VACUUM OPERATED WINDSCREEN WASHER.

DOOR SEALS FOR 'S' TYPE BENTLEY AND SILVER CLOUD.

FRONT DOOR WINDOW CHANNELS

Fig.1. Rubber Seal in position.

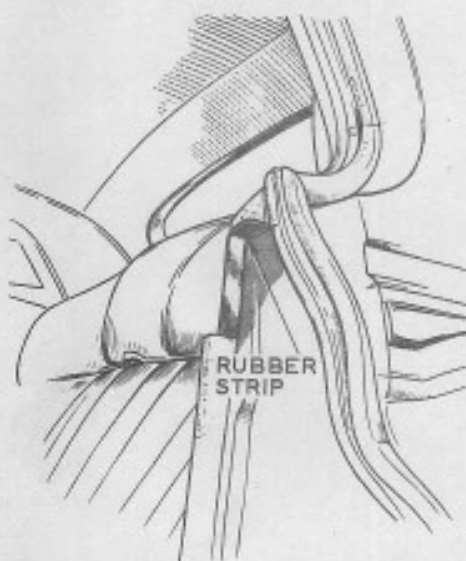
To obviate the discomfort caused by these draughts, it has been decided, in complaint cases, to fit a rubber compression seal behind the fixed waist rail finisher as shown in Fig.1.

1. Pull back rubber door seal to expose finisher retaining screws, which can then be removed. The finisher is then only held by a spring clip.
2. Position a piece of 0.032" thick rubber (UW.1635), approximately 1" x 3" between the inner side of the waist finisher and the body pillar, so that it just seats against the waist finisher fitted to the door.
3. Mark with a pencil and apply Bostik 252 adhesive to the rubber and fixed finisher contact areas.
4. Allow Bostik to become tacky, then fit into position finally.
5. Clean off any excess Bostik.

Fig.1.

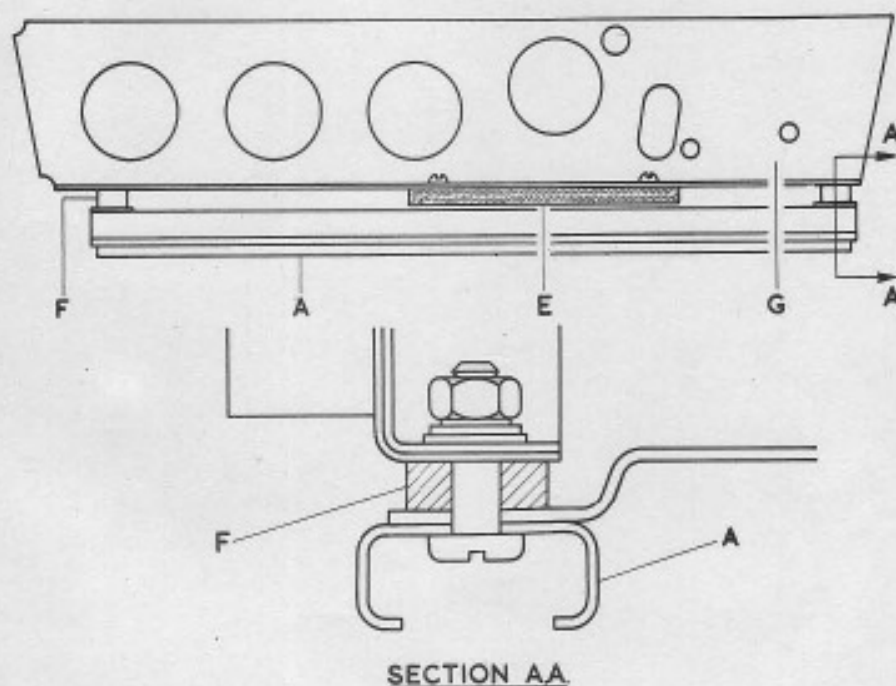
A rattle from the seat runner assembly can be due either to the woodscrews and setscrews securing the seat slides to the seats becoming loose owing to shrinkage of the hardwood mounting, or, the setscrews securing the slides to the floor becoming loose due to the localised setting of the leather trim around the screw holes in the hardwood mounting blocks during service.

The former fault can be overcome by fitting a shorter hardwood mounting block in the centre (E, Fig.1), and aluminium distance pieces (F, Fig.1) at the ends of the slides between the seat slides and the seat. The latter fault is rectified by bushing the holes in the hardwood mounting blocks, so that the floor slides, when tightened down, are set on the ends of the bushes, (D, Fig.2) and not on the leather trimmed hardwood.

The seat should be demounted and the seat slides removed. Replace the existing hardwood mounting with the two aluminium distance pieces and the short hardwood block using the existing woodscrews and setscrews (Fig.1).

FIG. 1.

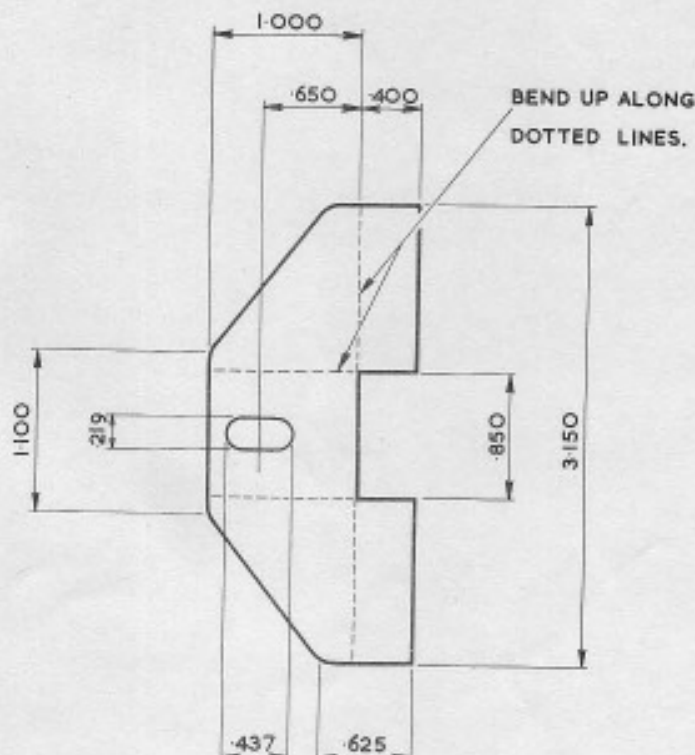
On production, the rigidity of the front lower glass channel brackets, has been increased to reduce flexing of the brackets, with consequent danger of fatigue and fracture, following extensive window winder operation.

In the event of new channel assemblies not being easily available, Retailers may manufacture new brackets in accordance with the following illustrations and dimensions.

- (a) Cut off existing bracket as shown in the inset.
- (b) Make up new brackets as detailed in Fig.1 using 18 gauge sheet steel, and bend as indicated.
- (c) Position on channel and weld all round as shown in Fig.2.
- (d) Clean up assembly and paint with a high quality Black Enamel.
